PLANNING BOARD
REVISED AGENDA
BRUNSWICK TOWN HALL
85 UNION STREET
COUNCIL CHAMBERS
TUESDAY, OCTOBER 25, 2016; 7:00 P.M.

DRAFT FINDINGS OF FACT
Major Development Review
Cumberland Farms Redevelopment Project
Planning Board Review Date: October 25, 2016

Project Name: Cumberland Farms
Address: 190 Bath Road
Brunswick, ME 04011
Case Number: 16-035
Tax Map: Assessor's Map CC1, Lot 28
Zoning: Cooks Corner Center (CC) Zoning District
Applicant: LHB Enterprises, Inc.
3 Battery Wharf, #3411
Boston, MA 02109

SITE PLAN
CFG04.0

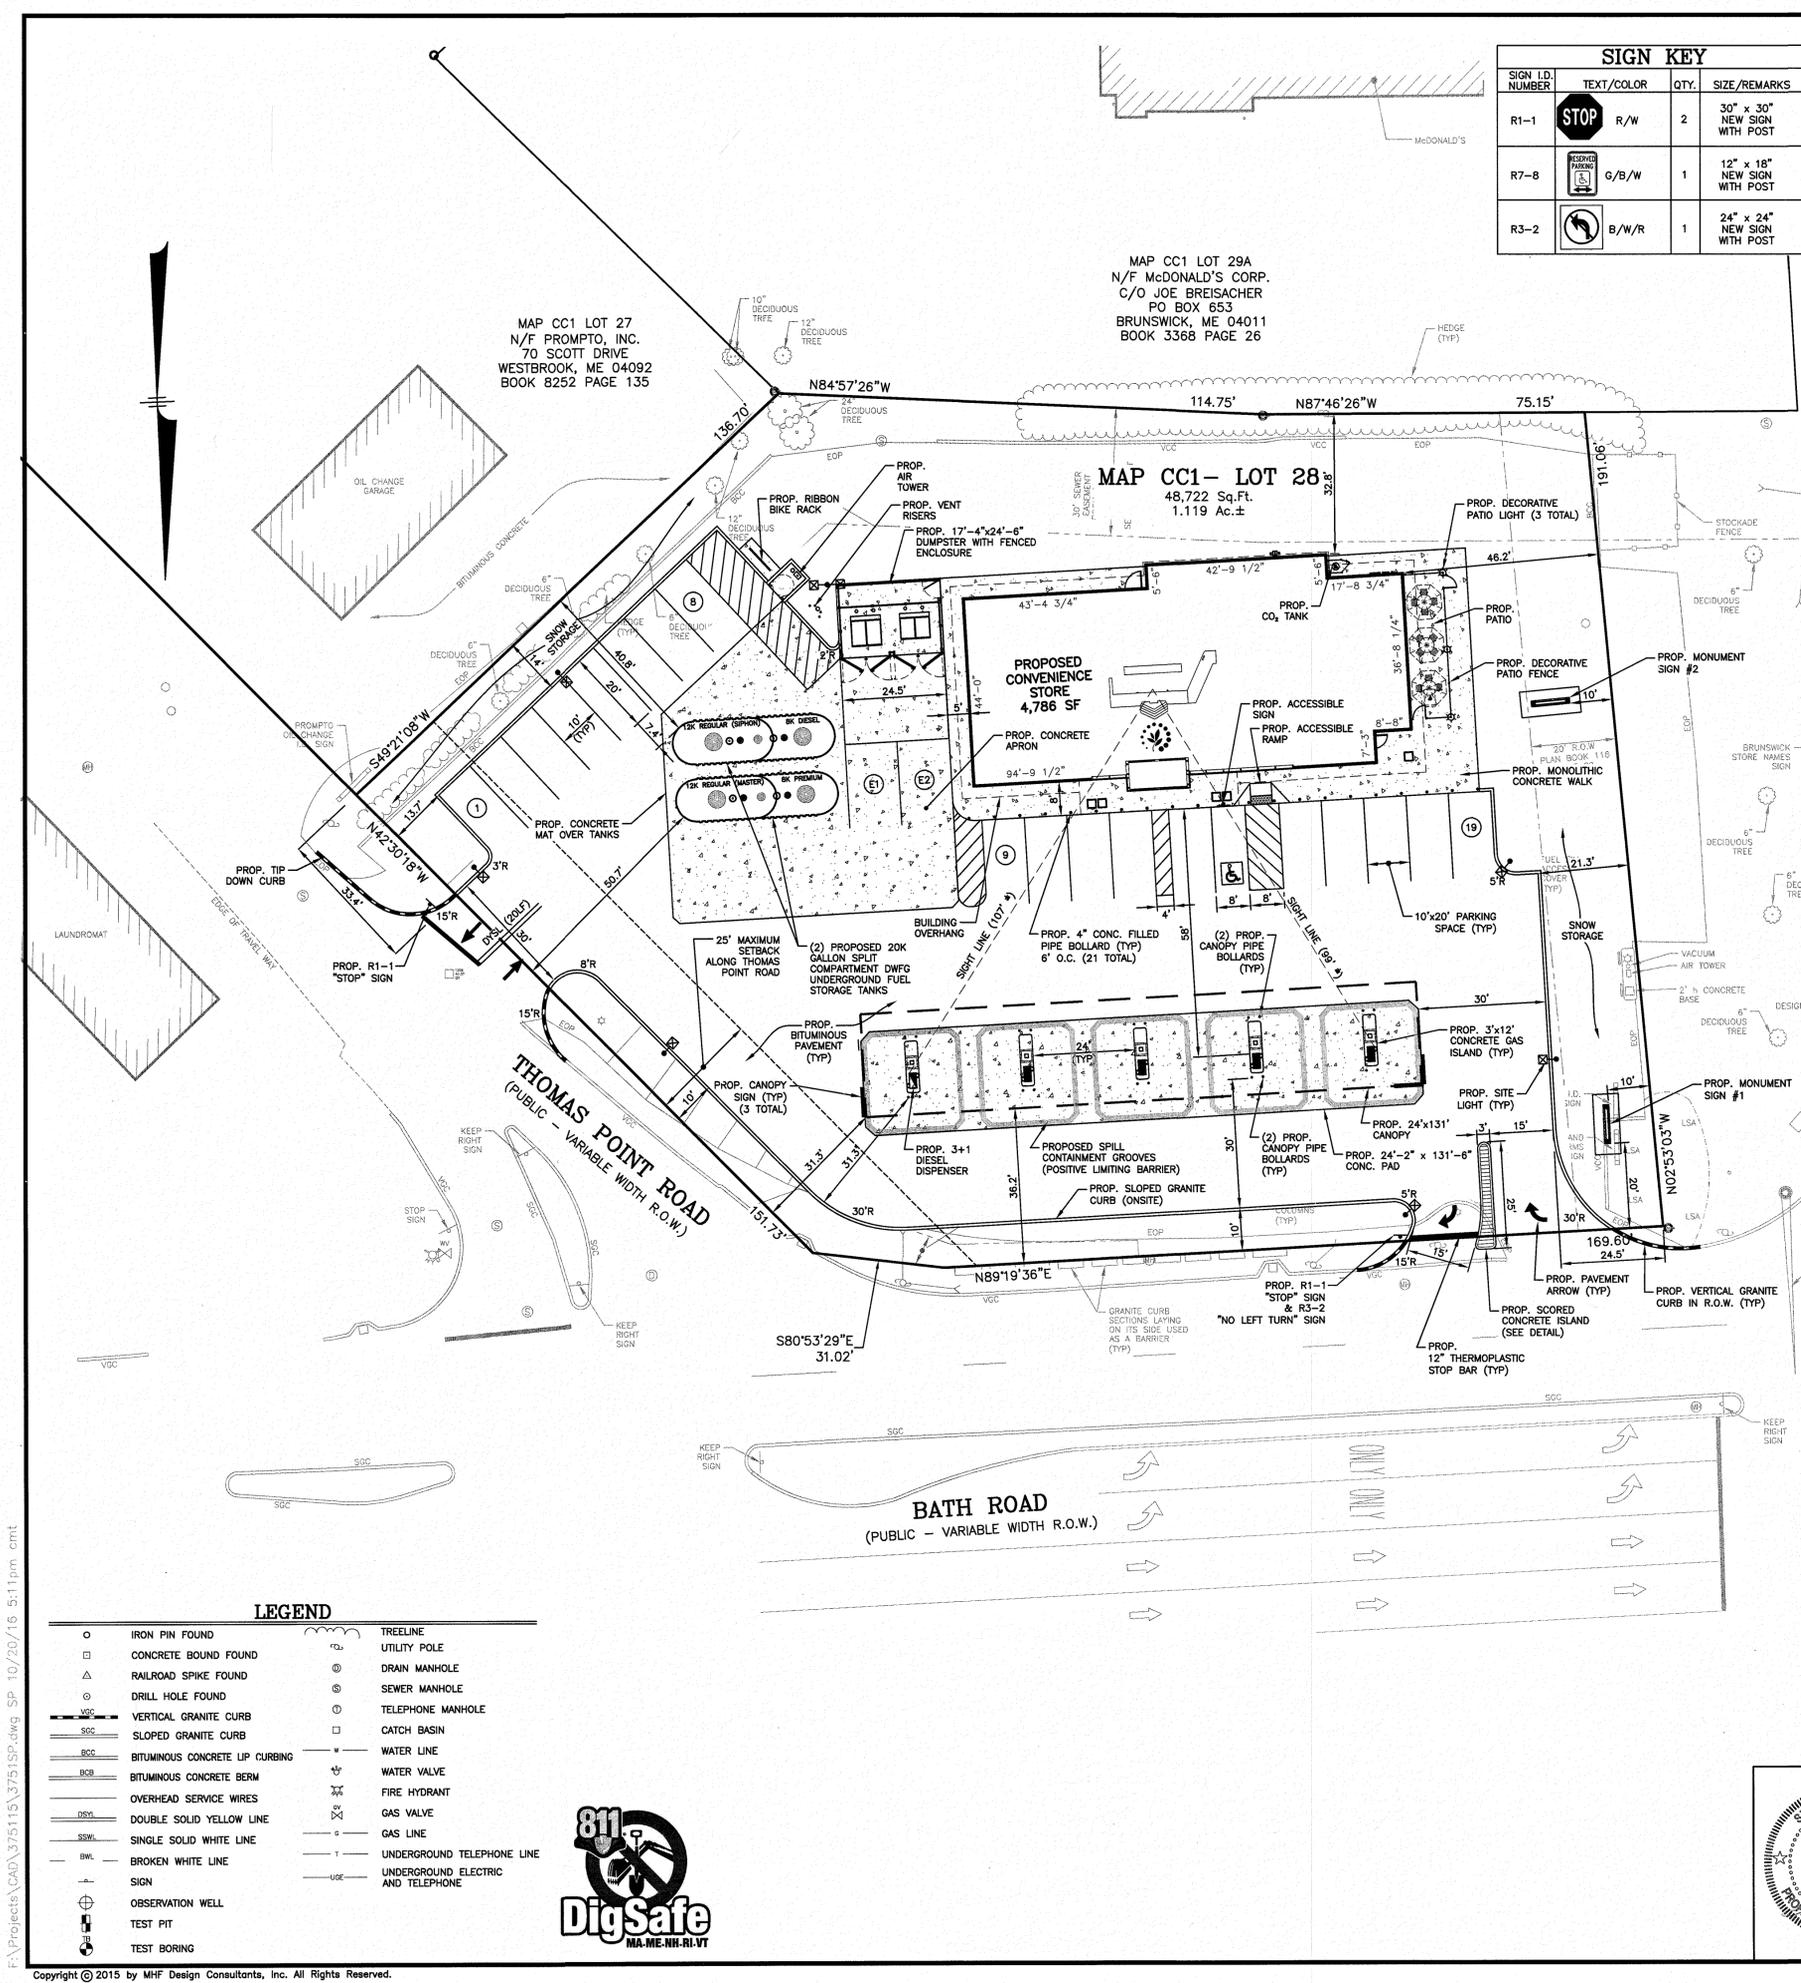
As indicated in the review, the third party engineer advised against allowing right turns from the current site entrance at Bath Road as proposed. The applicant provided a response to the third party review with notable findings including observations that the existing driveway at Bath Road currently accommodates two-way traffic, and crash history within the project vicinity indicates no cause for concern. On October 19, 2016, the applicant's representatives met with staff and the third party review consultants for the town to discuss alternatives to the proposed development to minimize the probability of public road congestion and unsafe conditions. During the meeting, the representatives for the applicant maintained their analysis indicates no concern is warranted; however, they agreed to site plan modifications to mitigate concerns for traffic congestion at the proposed two-way entrance including an approximately 25-foot long, three-inch tall raised and textured island at the driveway entrance to provide separation between lanes and serve as a deterrent to cross traffic entering the site from Bath Road. The applicant further considered widening the proposed entrance to accommodate the new island, and provide additional traffic safety at the Bath Road entrance. The applicant was advised to consider reorienting the dumpster enclosure at the west side of the proposed building to a smaller footprint in order to allow the building and pump stations to be shifted slightly to the west for added isle width, and safety improvements. Provided the applicant mitigates the Bath Road entrance to the satisfaction of the Town Engineer, the proposed project is not anticipated to cause unreasonable public road congestion or unsafe conditions. *The Board finds that the provisions of Section 411.12 are satisfied provided the Bath Road entrance is designed to the satisfaction of the Town Engineer.*

- Believes that changing the traffic pattern will have traffic coming out there more often, and with the way the pump islands are oriented, they are going to have a difficult time making a right turn out of that driveway, and are just going to impede traffic trying to come in from a busy road at a major intersection. He wouldn't recommend the plan.

3. Prior to issuance of a building permit, the Bath Road entrance is designed to the satisfaction of the Town Engineer and the approved design is depicted site plans are provide to the Director of Planning and Development.
